Wiltshire Council Planning Consultation Response

URBAN DESIGN

Application No: PL/2025/10020

Proposal: Variation of condition 2 (Approved Plans) relating to application PL/2022/06298.

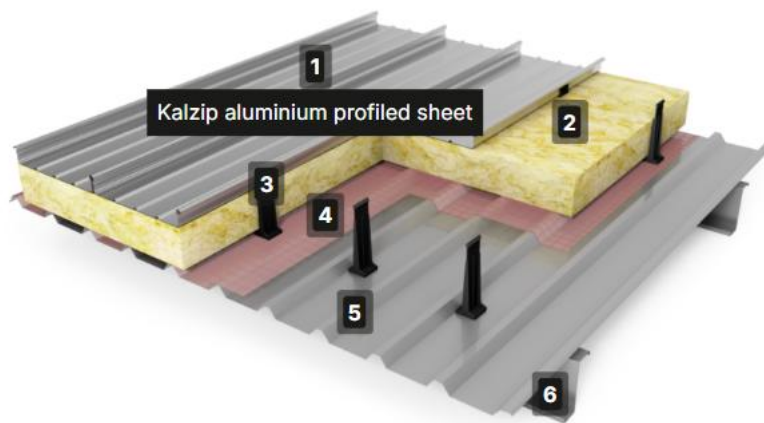
The local natural stone is a unifying key feature of Chicklade. Artificial stone slips and the painted steel sheet roof now proposed including its fascia trim, through initial appearance and weathering over time would not maintain that of a natural local stone faced façade and that of a high quality standing seam zinc roofing, this includes, the through fixings and fading of the painted roof finish to the steel roof product now proposed.

✗ The stone cladding system proposed is not of sufficient quality and will appear as a slip system, particularly at corner junctions to windows and doors as the slip depth is revealed. As noted previously the natural stone should be retained given the immediate setting of the National Landscape.

✗ It is acknowledged that the applicant has changed the roof material from the previous information submitted however this does not meet the design quality required. It will not emulate the consented standing seam zinc roof as it appears to have a profile between joints which does not reflect standing seam zinc (see below screenshot). Furthermore, due to the nature of the Kalzip panel there is a risk that the detailing, notably that of the eaves will not emulate detailing associated with standing seam roofs and give a cheaper, more industrial feel. It is recommended standing seam roofing is utilised. Zinc is recommended but If zinc is not possible then a more suitable standing seam alternative should be sourced. One possible solution could be Catnic Urban Seam Roofing.

It is acknowledged this is a much needed piece of infrastructure, and that construction viability is of importance, however this does not mean design quality should be watered down, a sentiment echoed by members of the public. Given the significance of the setting and the design changes being proposed as part of this revision, it is recommended that the material quality is kept consistent with the approved application.
